4 LOT SUBDIVISION

Day Street
Brooklyn, Connecticut

ENGINEERING PLAN REVIEW PERTAINING TO A 4-LOT SUBDIVISION CNG HOLDINGS, LLC (ASSESSOR'S MAP 42, LOT No. 32) DAY STREET BROOKLYN, CT (May 7, 2021)

CNS HOLDINGS, LLC
SUBDIVISION
DAY STREET
BROOKLYN, CT
GRADING AND SEPTIC DESIGN PLAN

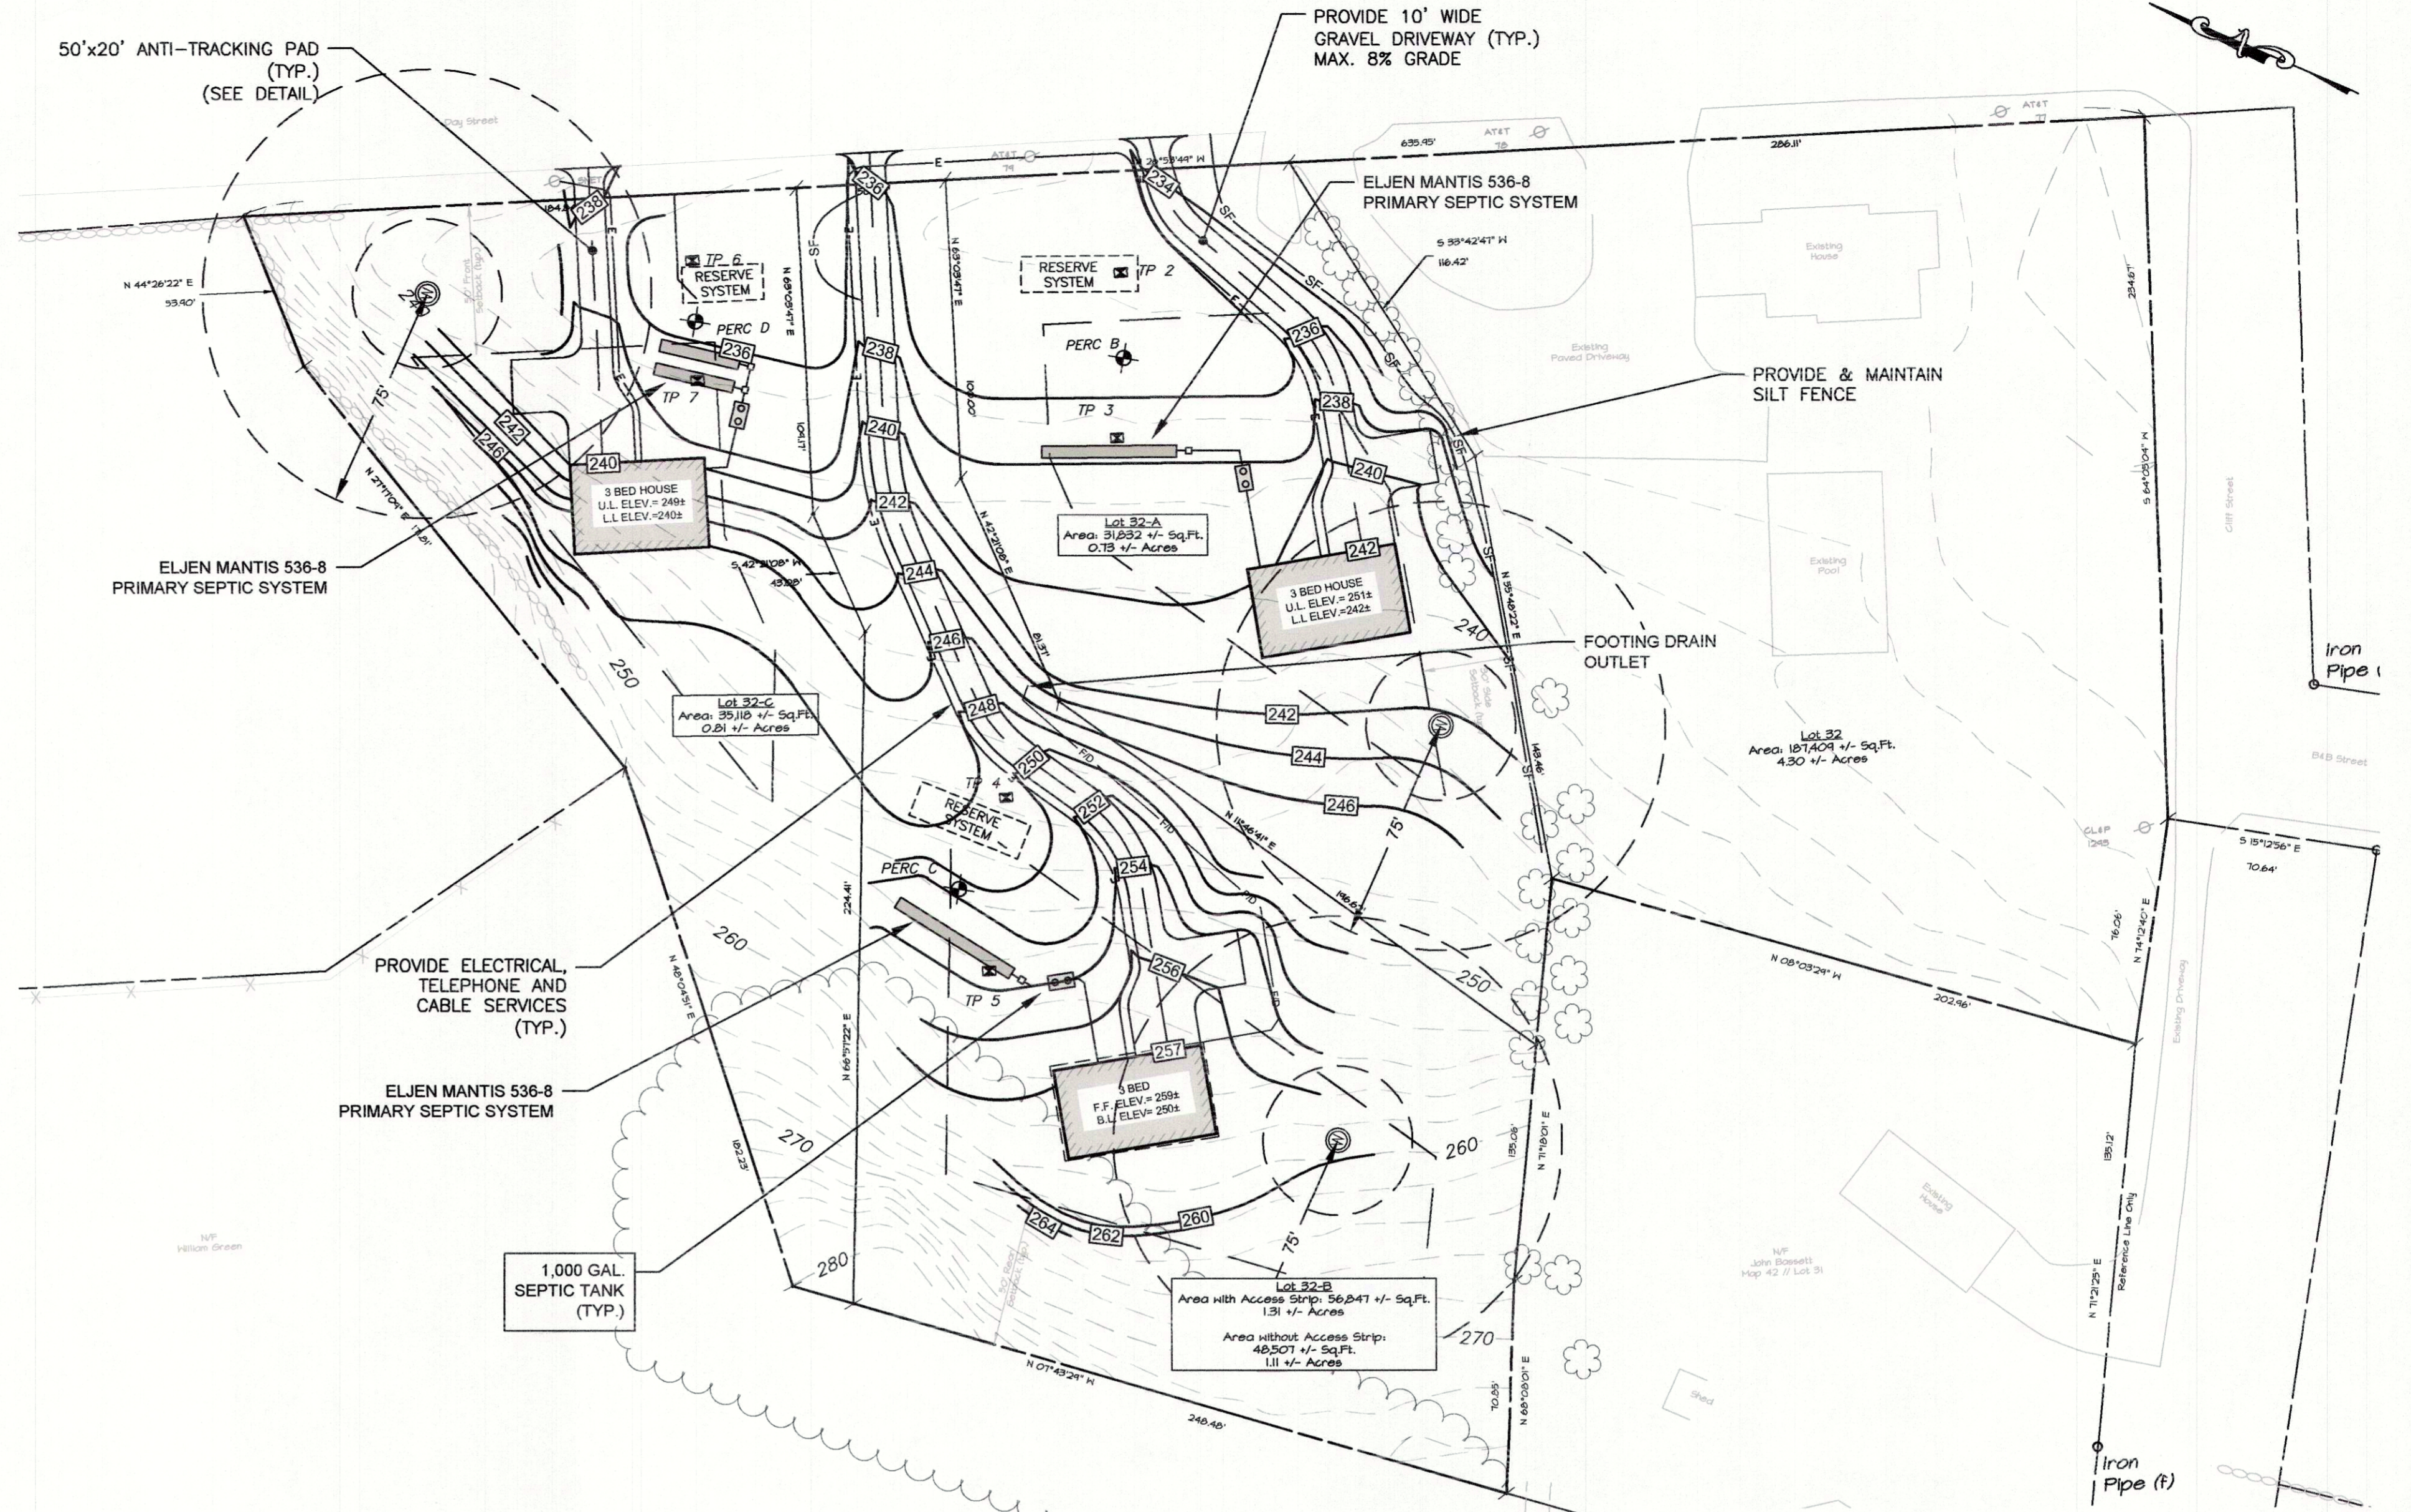
Sheet 4 of 7 – Grading and Septic Design Plan

1. Note 1 under “Notes” does not include the accuracy of the topographic elevations shown on the plan. The accuracy needs to be included as part of this note.
2. A benchmark needs to be shown on the plan.

3. A silt fence, compost/silt sock and/or hay bale sediment control symbol needs to be included in the "Legend."
4. The slopes around the west side of the house footprint on Lot 32-C and need to be changed to no steeper than 3:1. If this cannot be met, a retaining wall will need to be designed for this location in order to provide adequate clearance around the house, especially in consideration of firefighting.

5. The proposed slope to the west of the house footprint on Lot 32-B is too steep and must be depicted as no steeper than 3:1.
6. A retaining wall may be necessary to the south of the driveway "tongue" on Lot 32-C, as a too steep slope is shown there.

7. A note needs to be placed on the plan stating that no slopes greater than 3:1 are allowed.
8. All angle points in the property lines are to be marked with detectable markers, e.g. iron pins, with a symbol placed in the "Legend."

9. All front, side yard and rear yard setbacks are to be labeled on the plan.
10. Paved driveway aprons need to be shown on the plan

TRENCH DETAIL: SANITARY SEWER SERVICE NOT TO SCALE

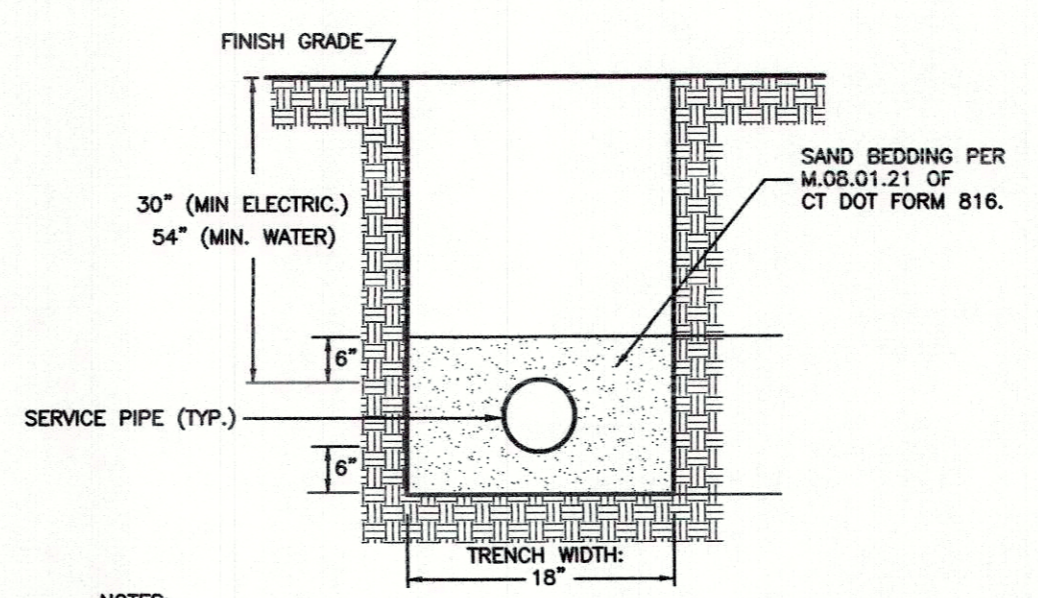
1. Any reference to CT DOT Form 816 is to be changed to the current Form 818 designation.
2. A detectable warning tape needs to be shown over the pipes in "The "Trench Detail: Sanitary Sewer Service" and "Typical Service Pipe Trench Detail."
3. A paved driveway apron detail needs to be included on this plan.
